RE: Bid Title: Construction of Leon County Public Library Eastside Branch
Bid No: BC-06-08-10-33
Opening Date: Tuesday, June 8, 2010 at 2:00 PM

ADDENDUM #3

This letter serves as Addendum #3 for the above referenced project.

ELECTRICAL LIGHTING PLAN

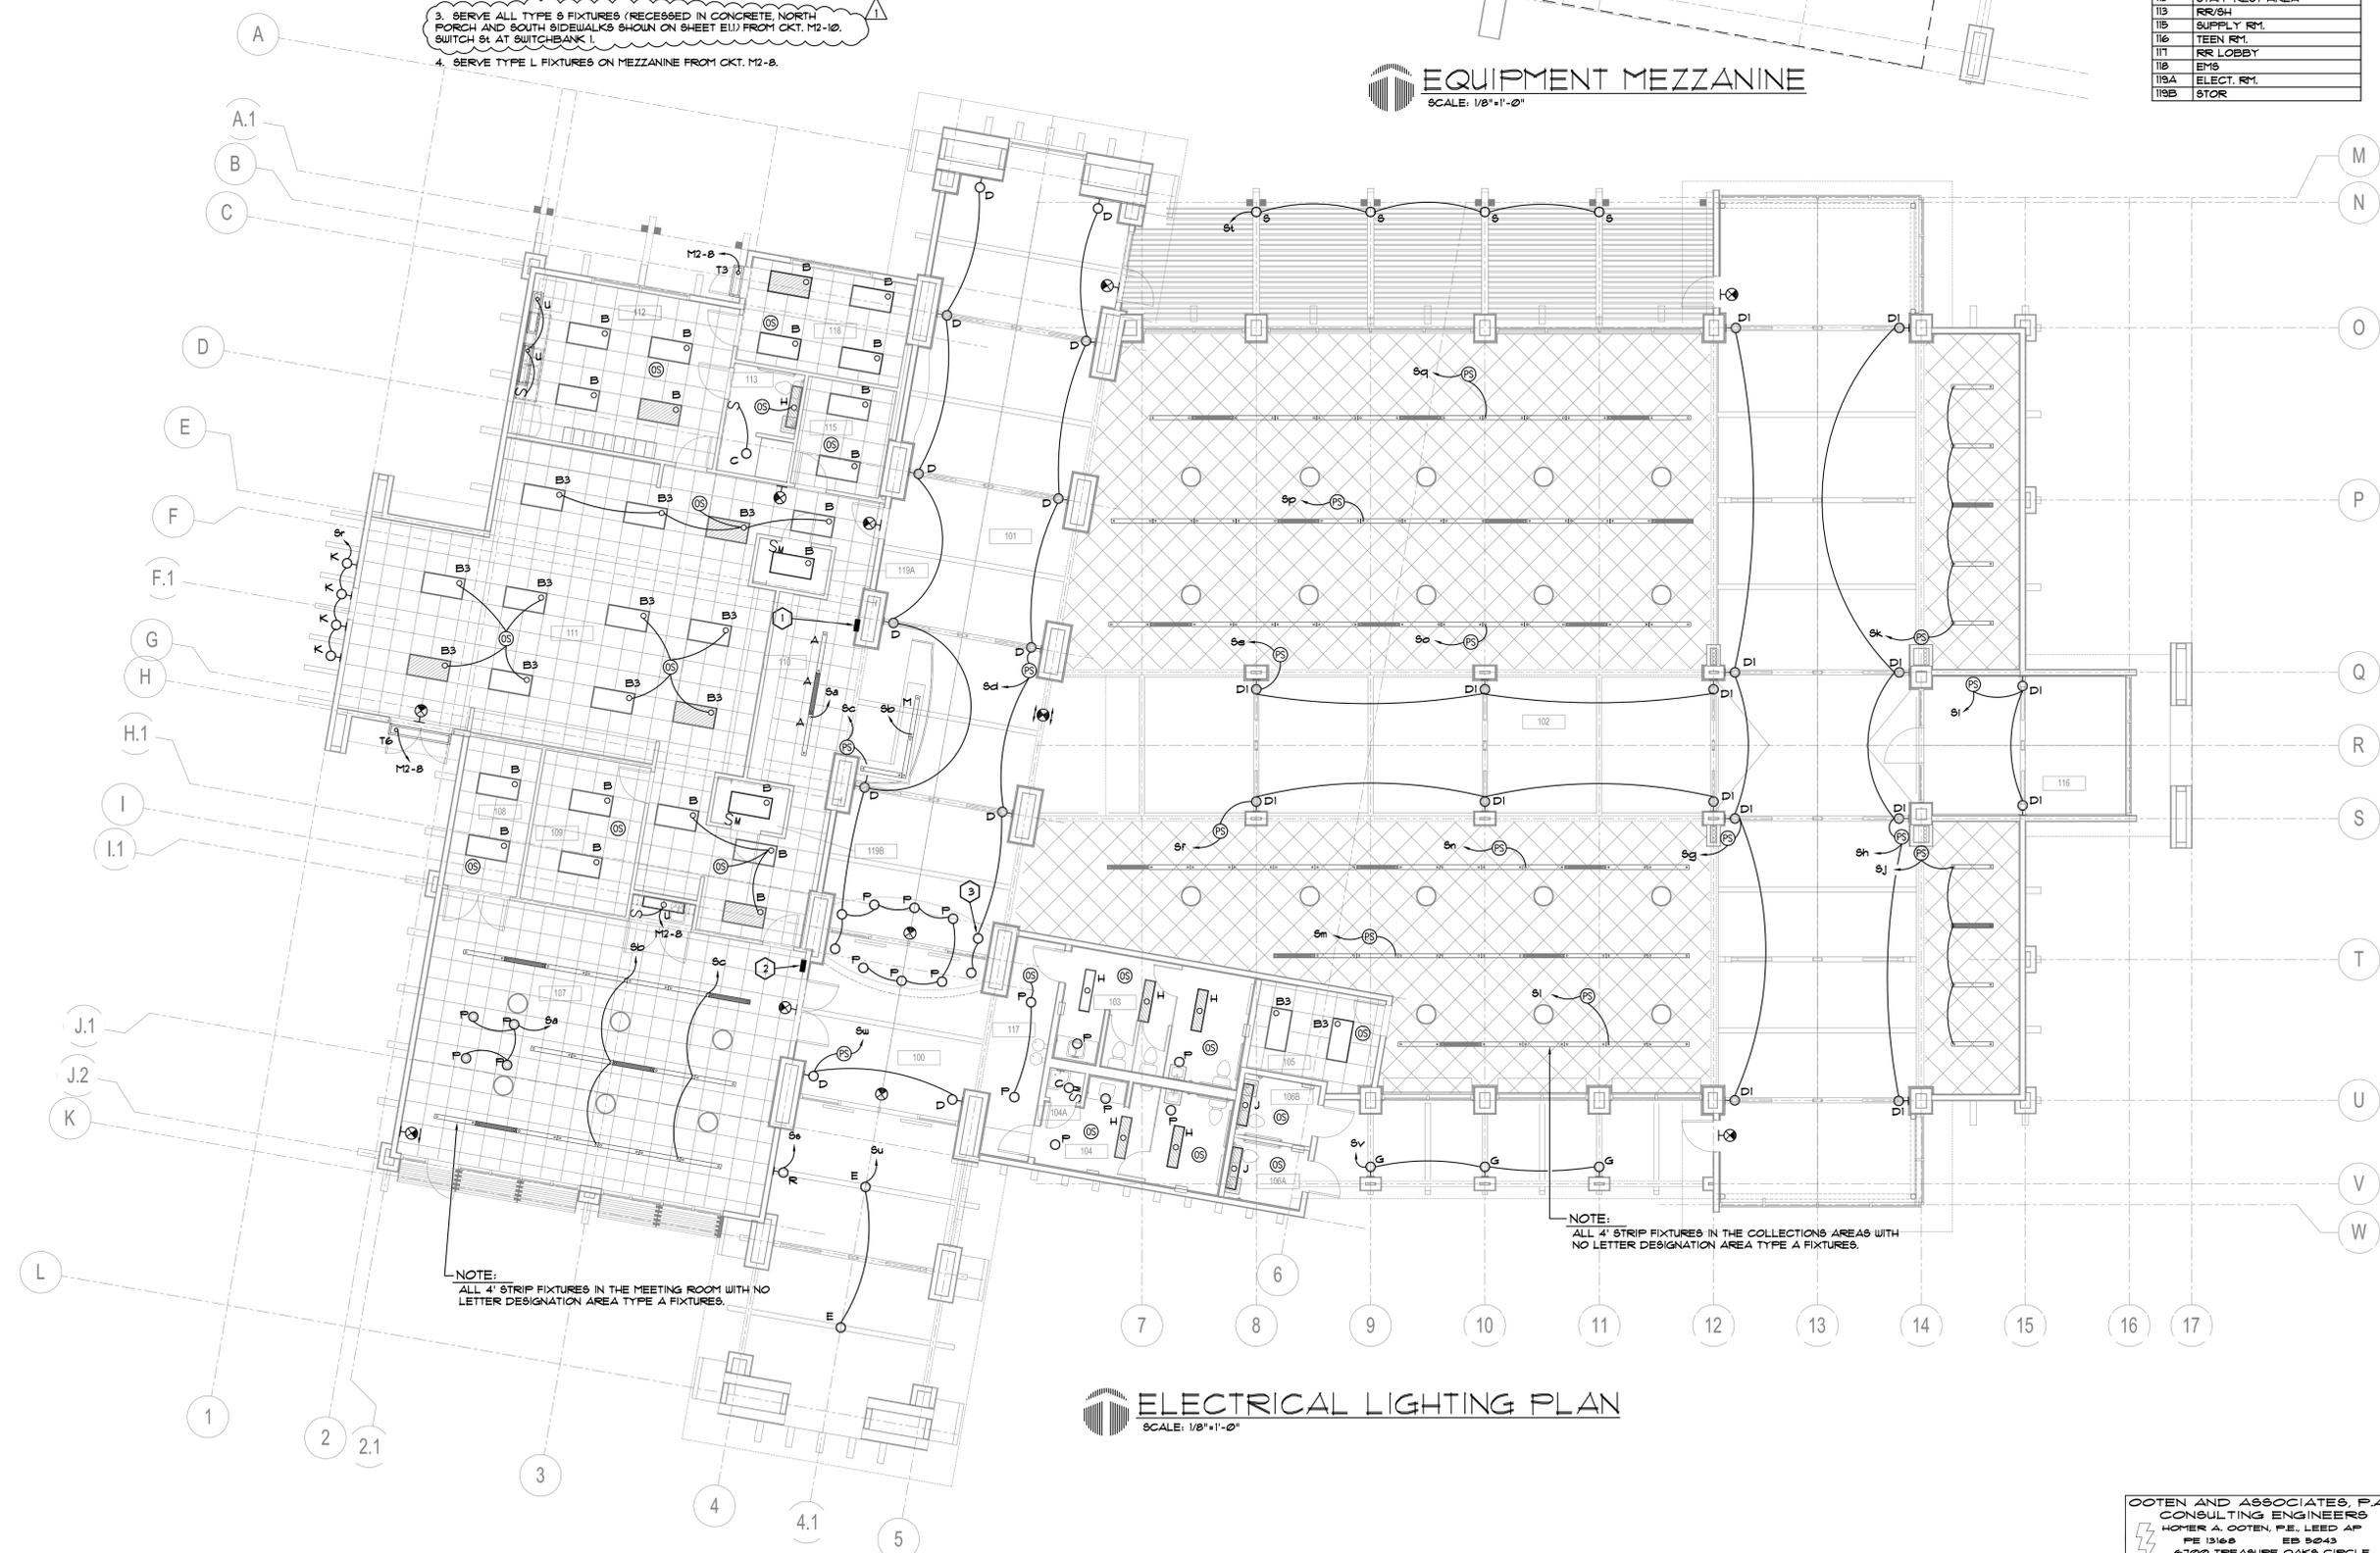
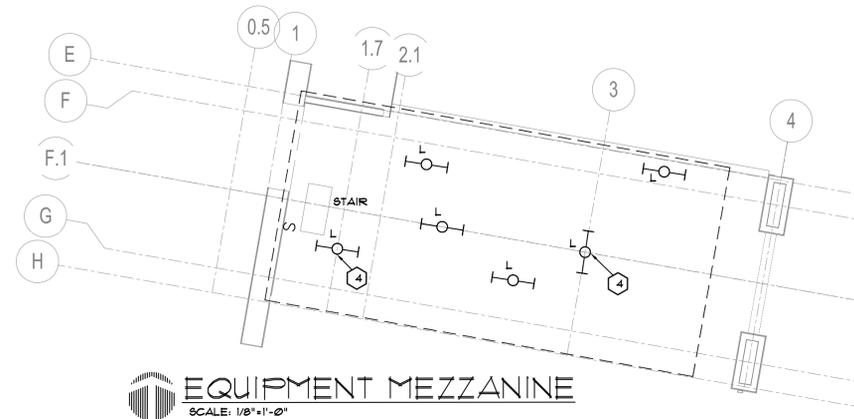
E3: *Reference Electrical Sheet E2.0.* - Add clarifications pertaining to the switchbank information and the Lighting Control System. See attachment.

E6: *Reference Electrical Sheet E2.0 & E2.1.* – **Clarification** - The switch banks are actually control stations as part of the Intelligent Lighting Control (ILC) System shown on Sheet E2.1. All such controls fit into one 4-gang recessed box. Local contact for the ILC system specified is Jeff Crisp, 850-422-3600. Further, see Lighting Control Notes on Sheet E2.0.

ELECTRICAL POWER PLAN
SCALE: 1/8"=1'-0"

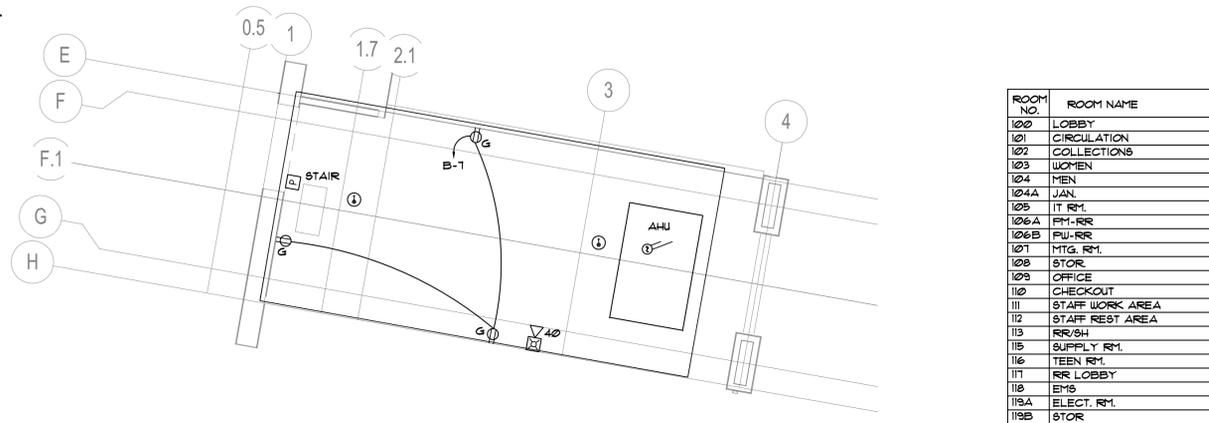
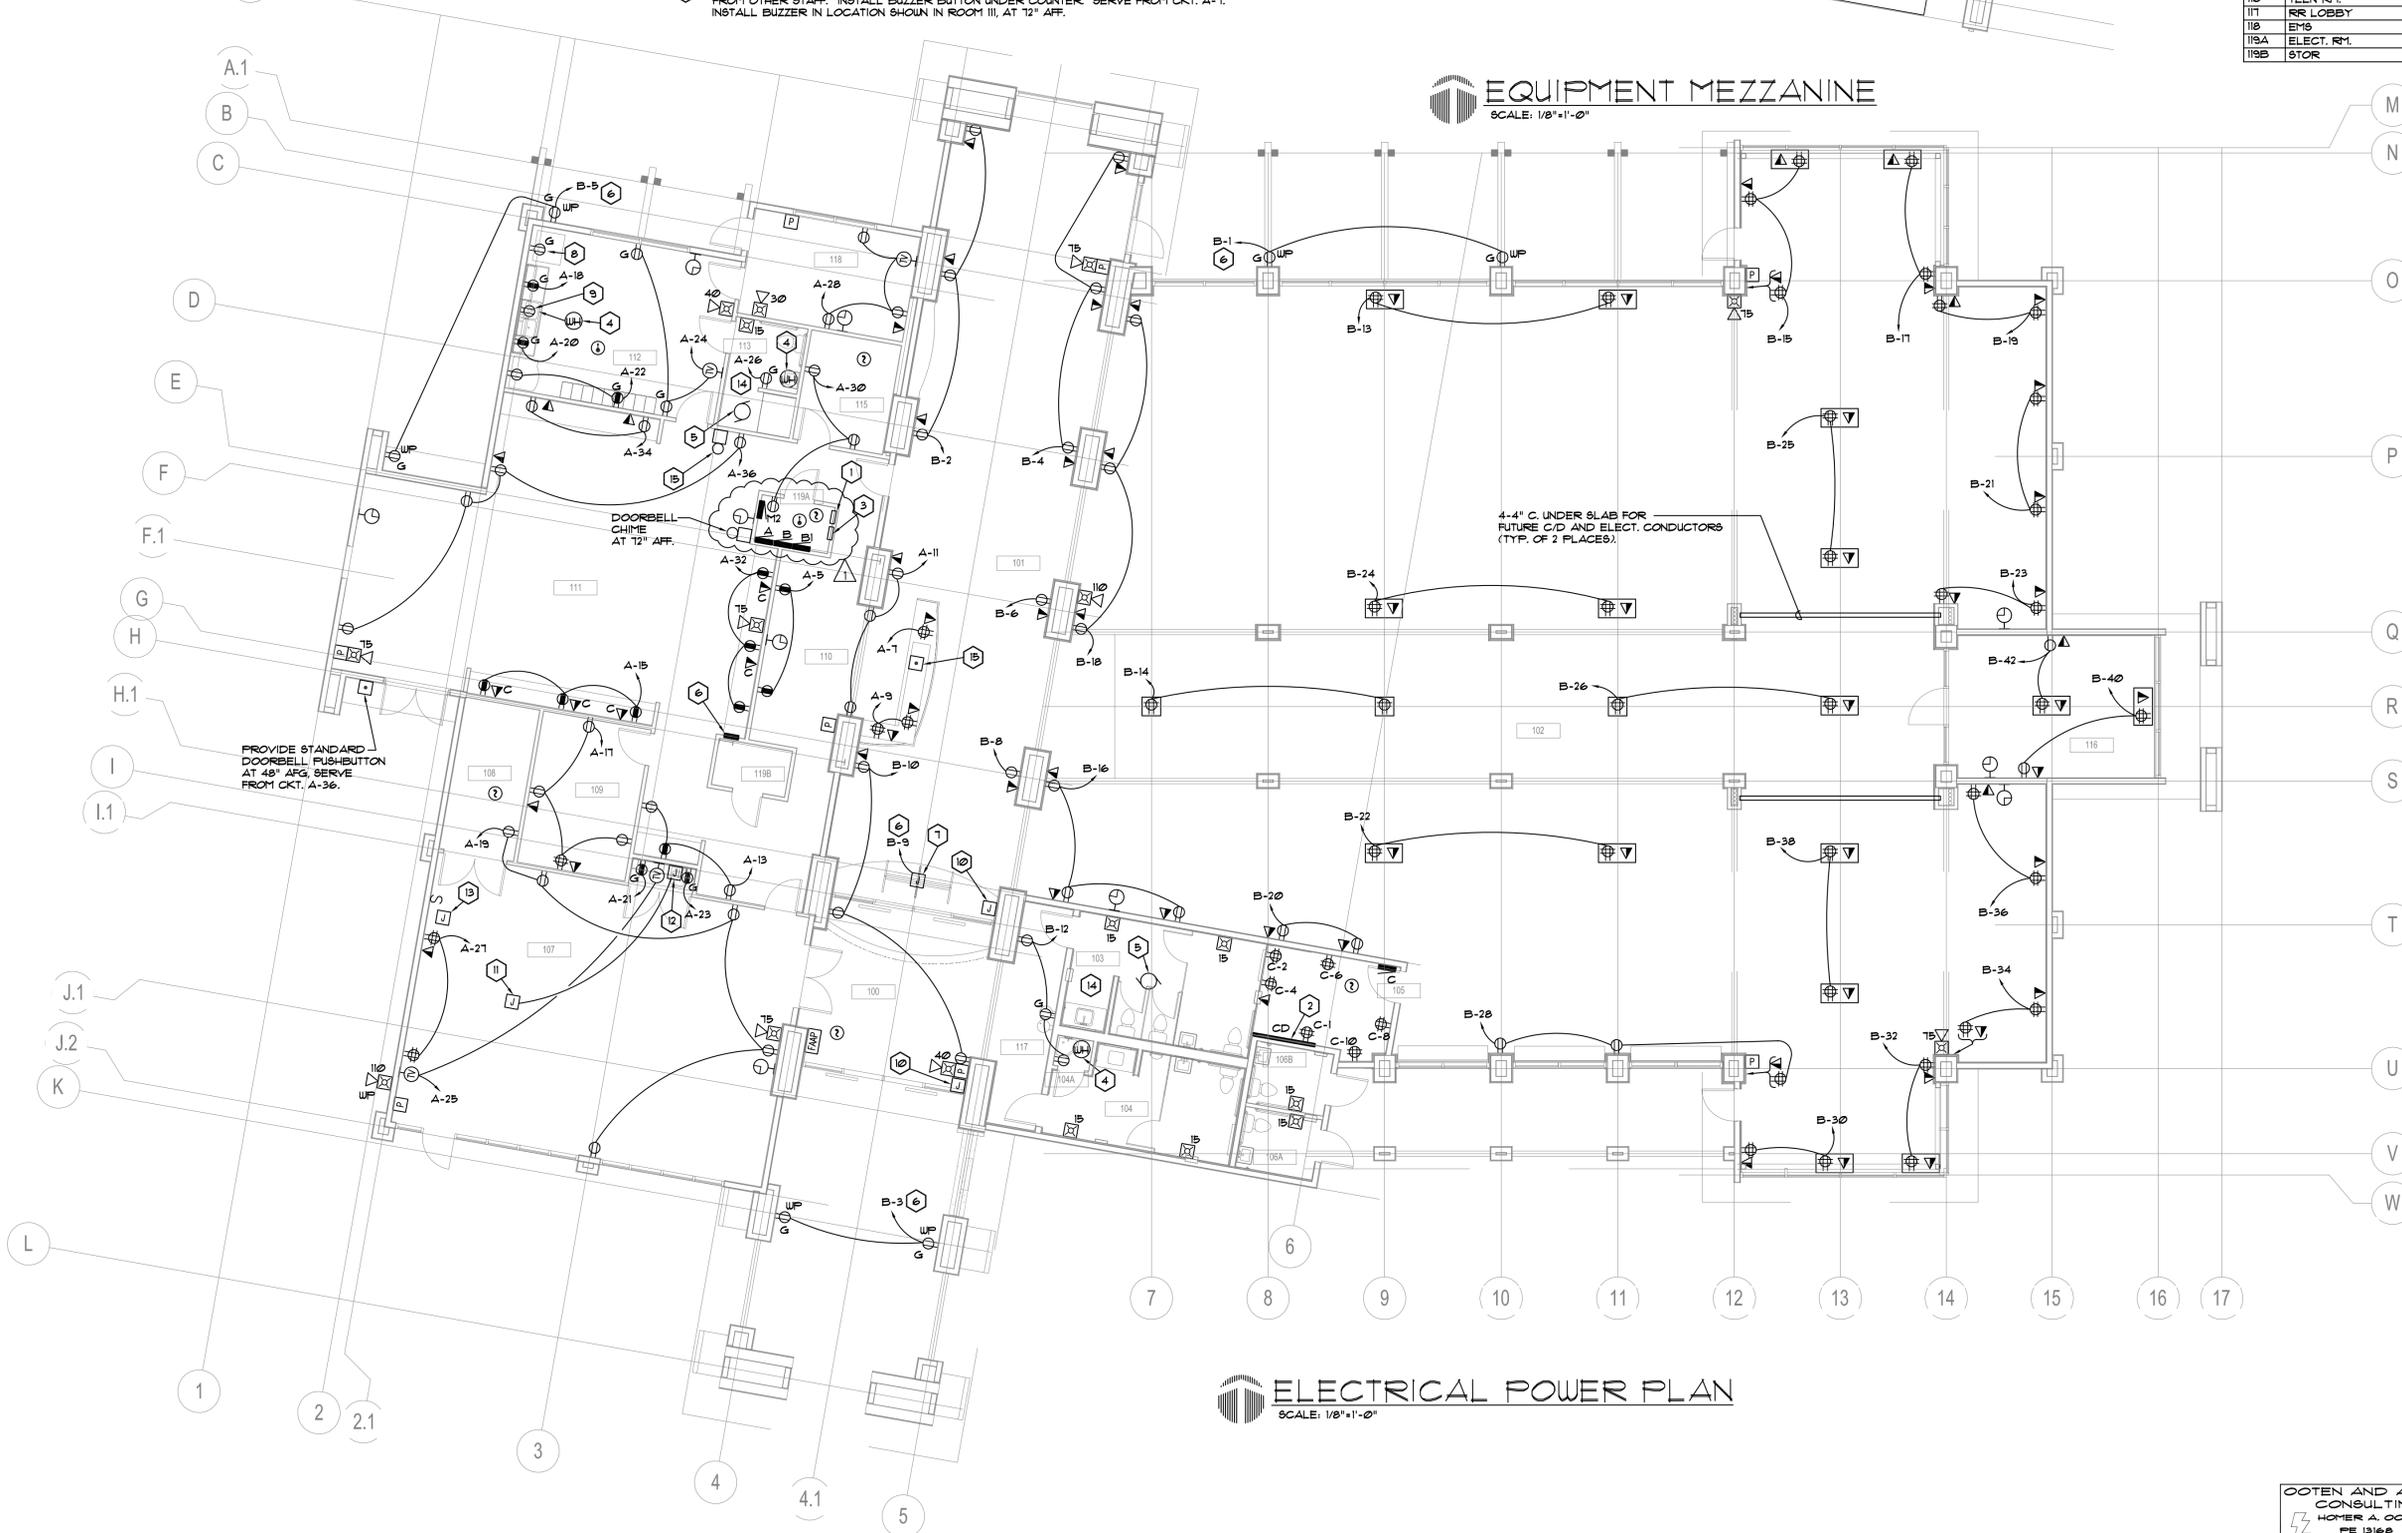
E4: *Reference Electrical Sheet E3.0.* - In Electrical Room 119A, add a smoke detector above the Fire Alarm Control Panel. See attachment.
